NETWORK SERVICE BULLETIN

JBL MODEL 3141

CIRCUIT:

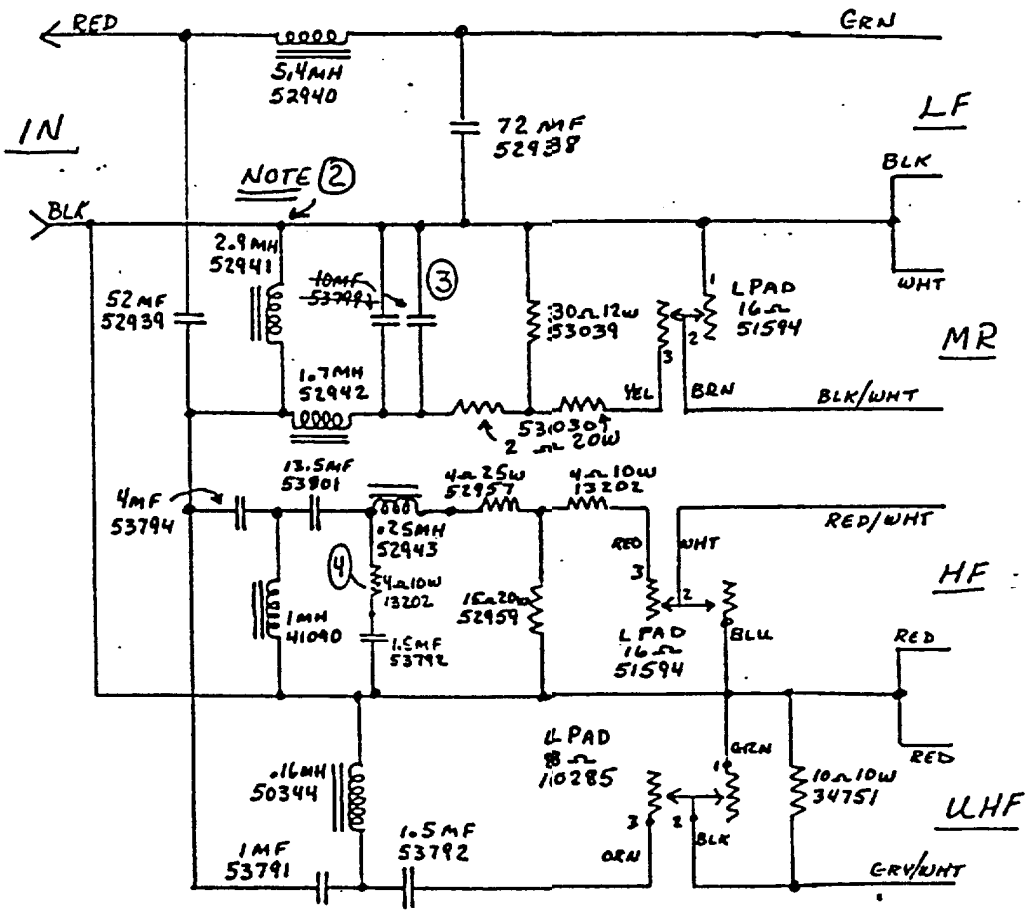
② EARLY UNITS USED A 2.9MH INDUCTOR MADE FROM A 10421P ASS'Y., WHICH MEASURES $1\frac{1}{8}$" x $1\frac{1}{8}$" x 7/8". ALL UNITS FOUND TO HAVE THIS SMALL PART MUST BE MODIFIED BY USING THE 52941 INDUCTOR MADE FROM A 10350P ASS'Y, WHICH MEASURES 2 x 2 x $1\frac{3}{8}$. (E.O. 93138 1-2-75)

③ TWO 10MF (53799) CHANGED TO ONE 20MF (53881)

④ ADDED 4Ω 10W RESISTOR TO PROTECT AMPLIFIER

CIRCUIT:

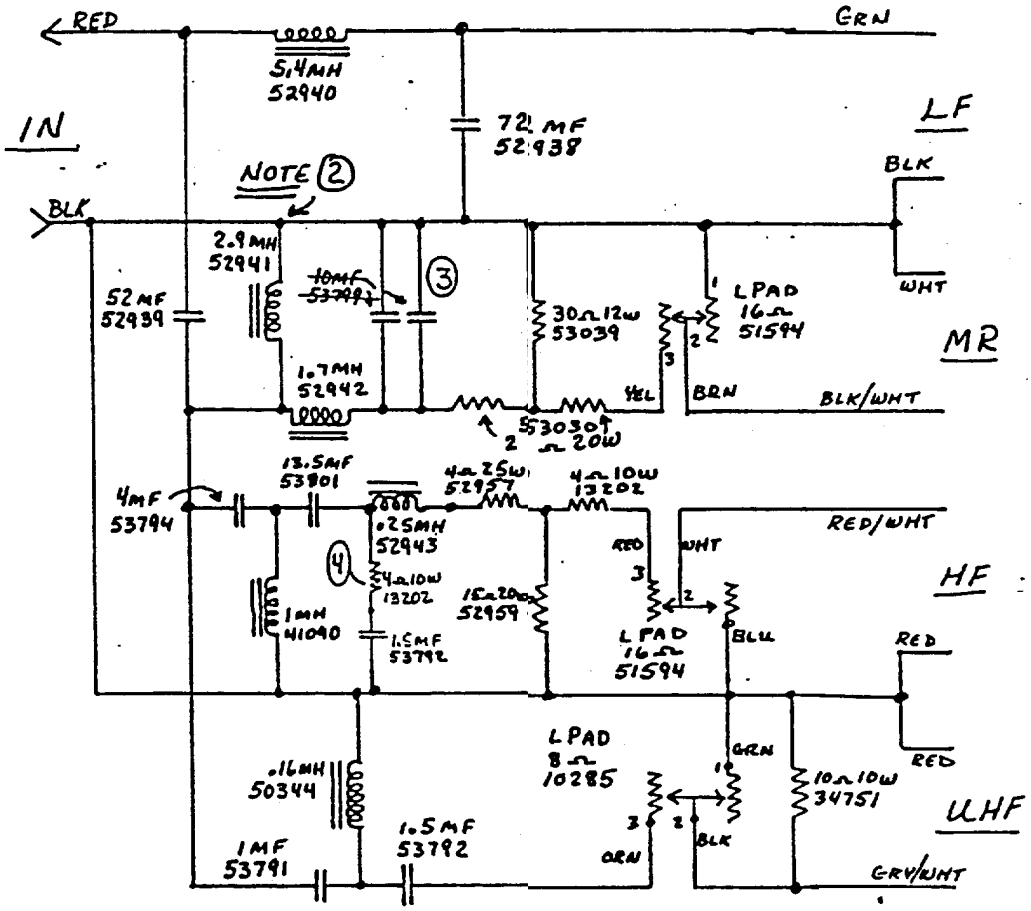
② EARLY UNITS USED A 2.9MH INDUCTOR MADE FROM A 10421P ASS'Y., WHICH MEASURES $1\frac{1}{8}$" x $1\frac{1}{8}$" x 7/8". ALL UNITS FOUND TO HAVE THIS SMALL PART MUST BE MODIFIED BY USING THE 52941 INDUCTOR MADE FROM A 10350P ASS'Y, WHICH MEASURES 2 x 2 x $1\frac{3}{8}$. (E.O. 93138 1-2-75)

③ TWO 10MF (53799) CHANGED TO ONE 20MF (53181)

④ ADDED 4Ω 10W RESISTOR TO PROTECT AMPLIFIER
